**MINUTES
BOARD OF BUILDING STANDARDS/
ARCHITECTURAL BOARD OF REVIEW/SIGN REVIEW
SPECIAL REVIEW MEETING
CITY OF LAKEWOOD
12650 DETROIT AVENUE
AUDITORIUM
OCTOBER 26, 2022
5:30 P.M.
<https://www.lakewoodoh.gov/videos-2/>**

**Heritage Advisory Board Report to Architectural Board of Review
Regarding the Application for a Certificate of Appropriateness to Alter the Curtis Block**

**Statement of the Lakewood Historical Society's Preservation Committee Submitted to the
Architectural Board of Review in Connection with its Review of a Certificate of
Appropriateness for Alterations to the Curtis Block**

Docket 07-42-22

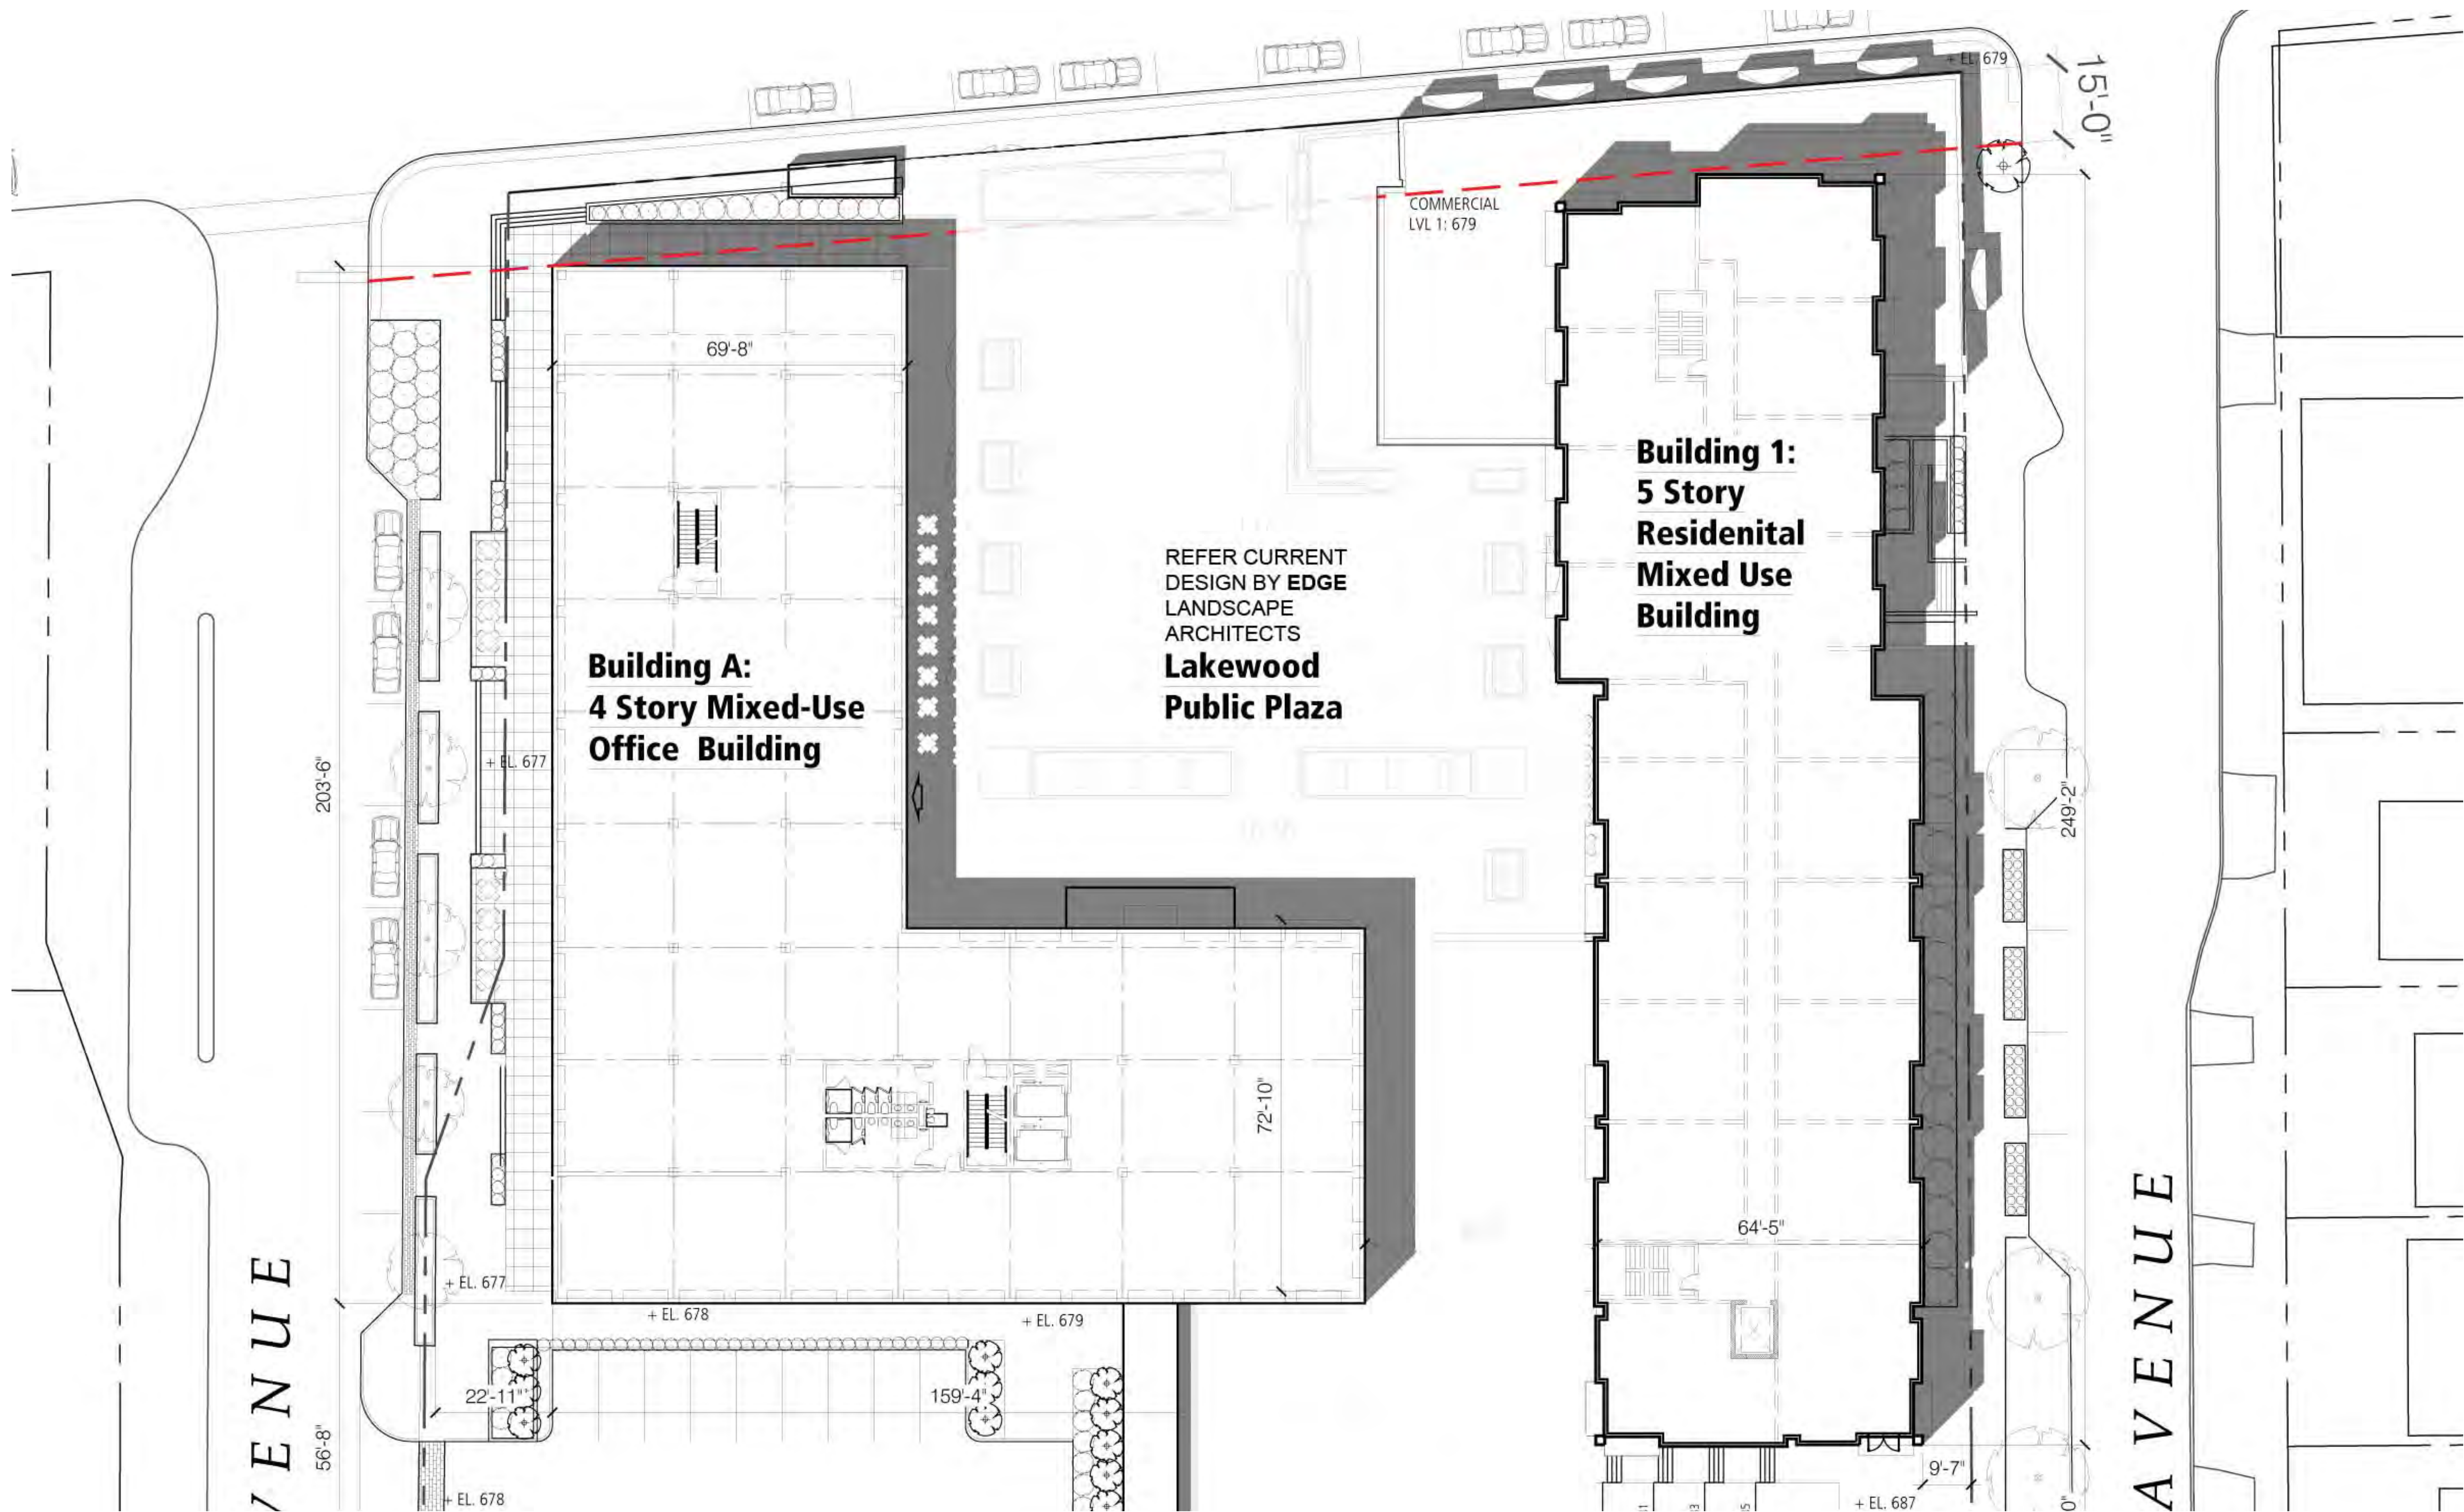
Finally, **removal of the apartment units on top of the building**, which leads us to the parking garage.

Some Planning Commission members were uncomfortable with the long, blank garage wall to be created, which would be hundreds of feet long. The garage wall is set back about 25 to 28 feet from the sidewalk. Planning Commission members encouraged the construction of townhouses between the garage wall and the sidewalk.

That provides a location for units removed from above the Curtis Block.

DETROIT AVE ELEVATION

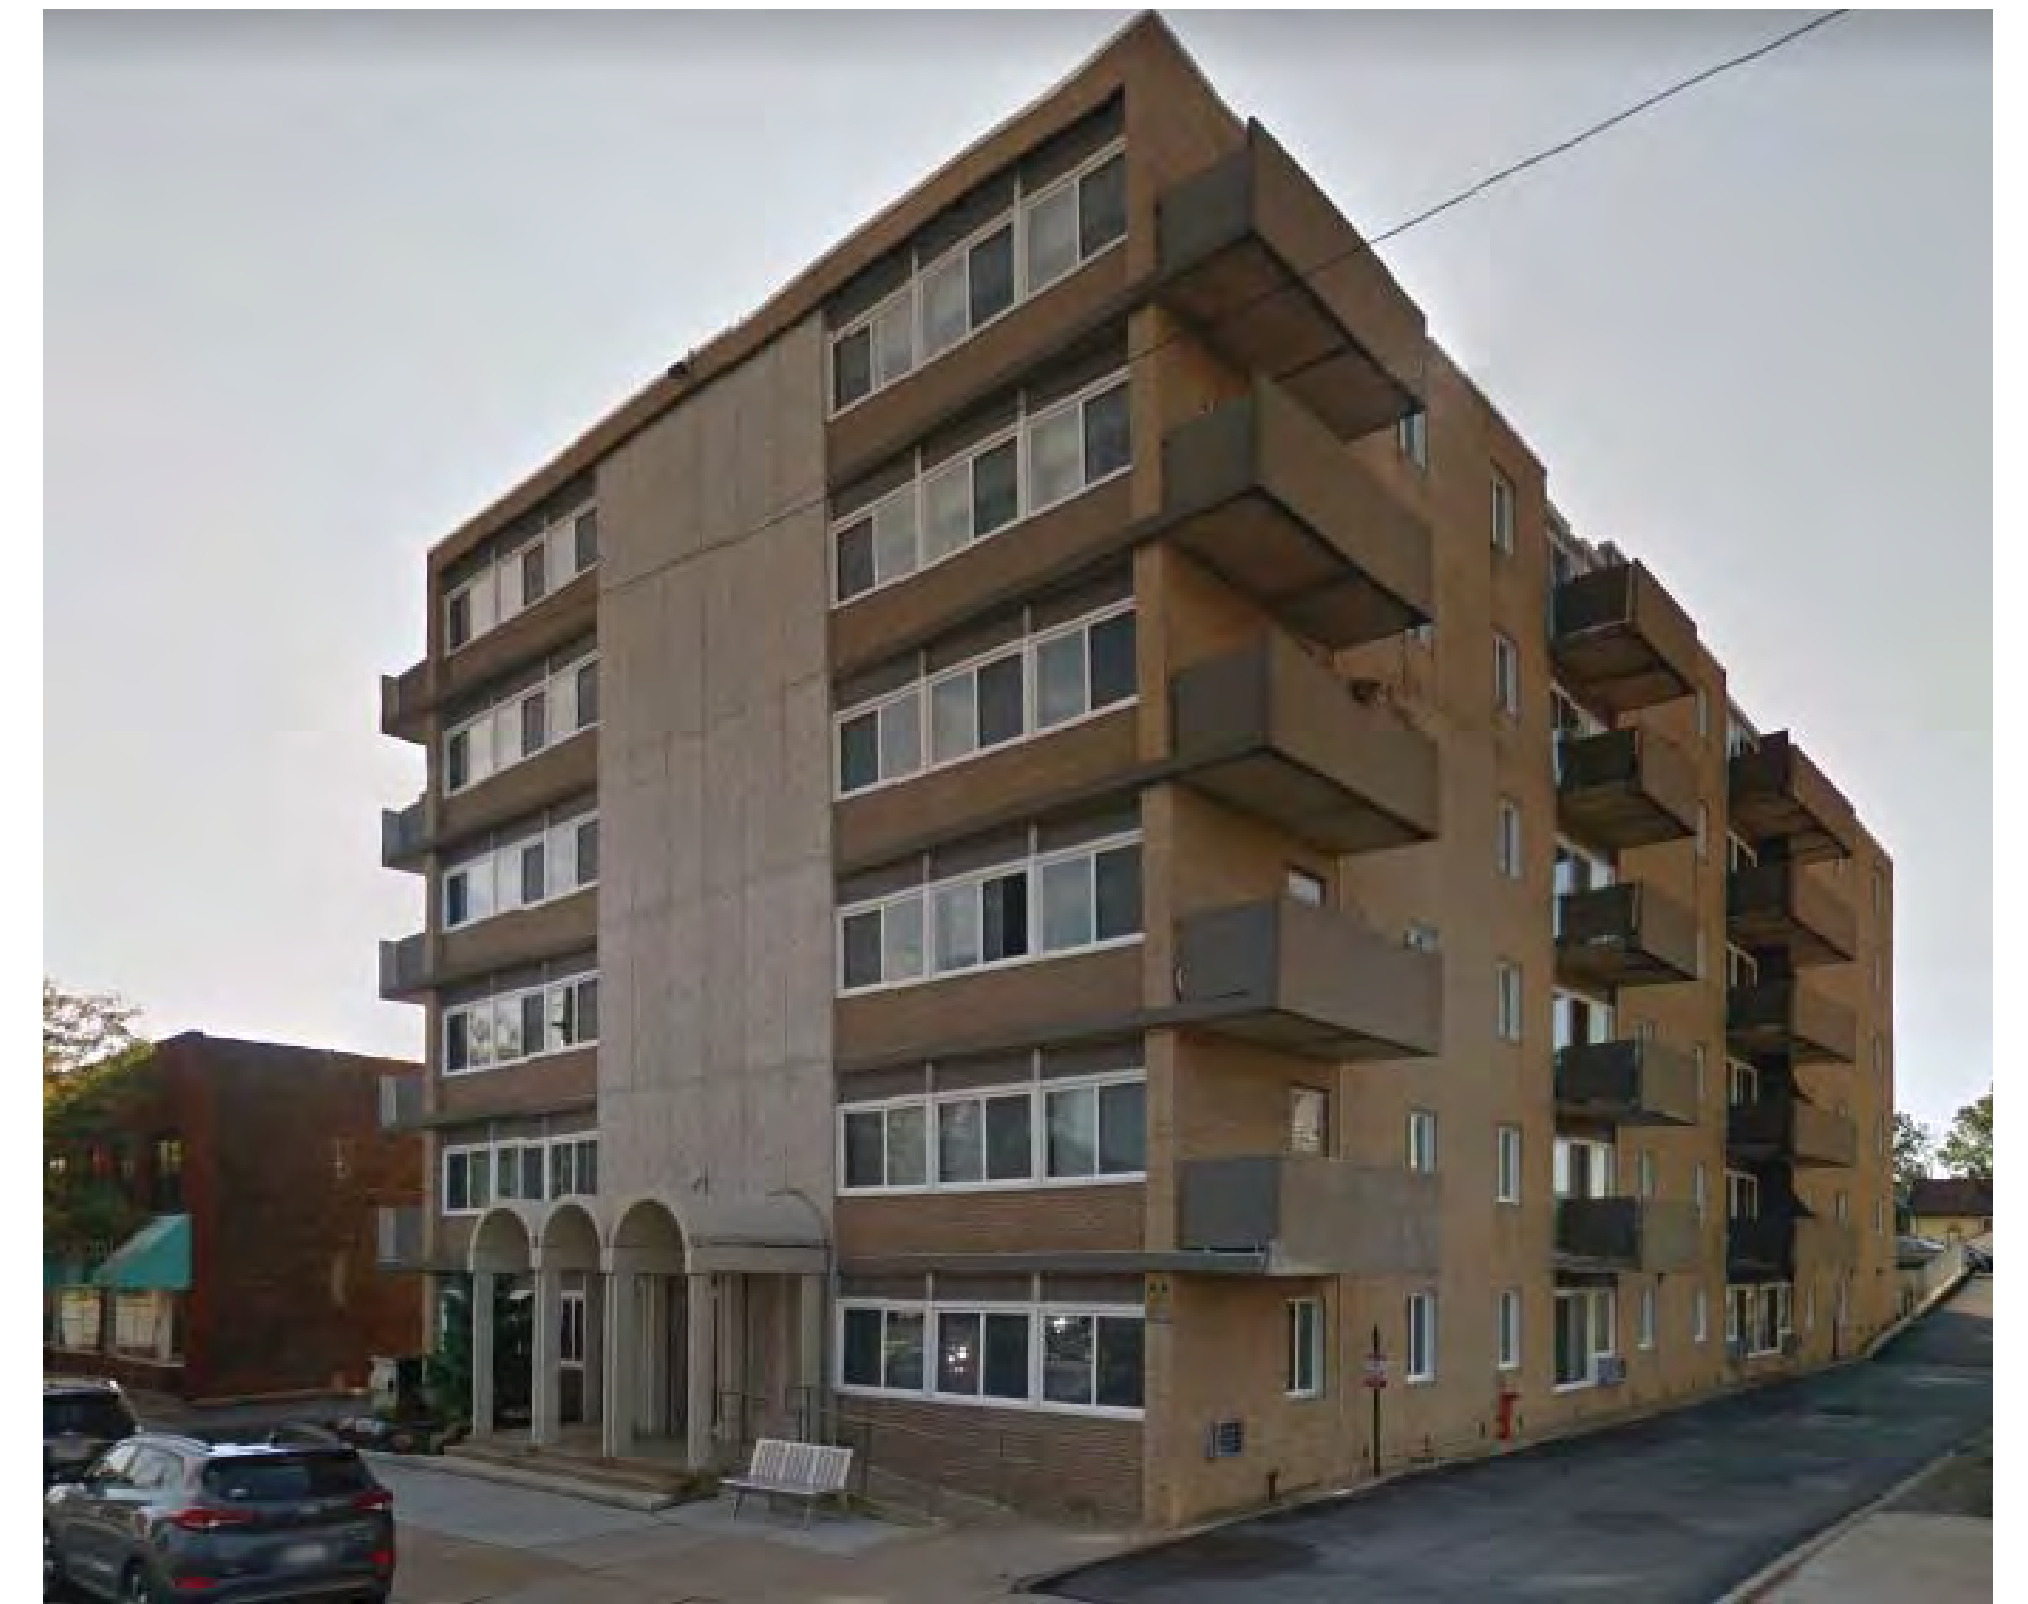
These two walls need to have the same appearance as today.

- Six bay windows with their wood panels, tile roofs, and distinctive small pane windows.
- Five recessed entrances with the traditional Lakewood streetcar era storefront parts of bulkheads, windows, and transoms.
- Three pairs of double doors with transoms, which provide access to the second floor.

Not all of the recessed entrances and second floor access points need to function, but they need to remain in place.

The developer plans to remove all the entrances and create a continuous line of windows. The Planning Commission took issue with this approach, which would leave a building fronting on Detroit Ave. with no Detroit address, and which would likely be the place that one or more tenants would want signage. There is flexibility. One or more of a combination of the east, central, or west storefronts can be functioning entrances, storefront sections can be opened to one another on the interior with steel beams, and incrementally differing floor levels (which
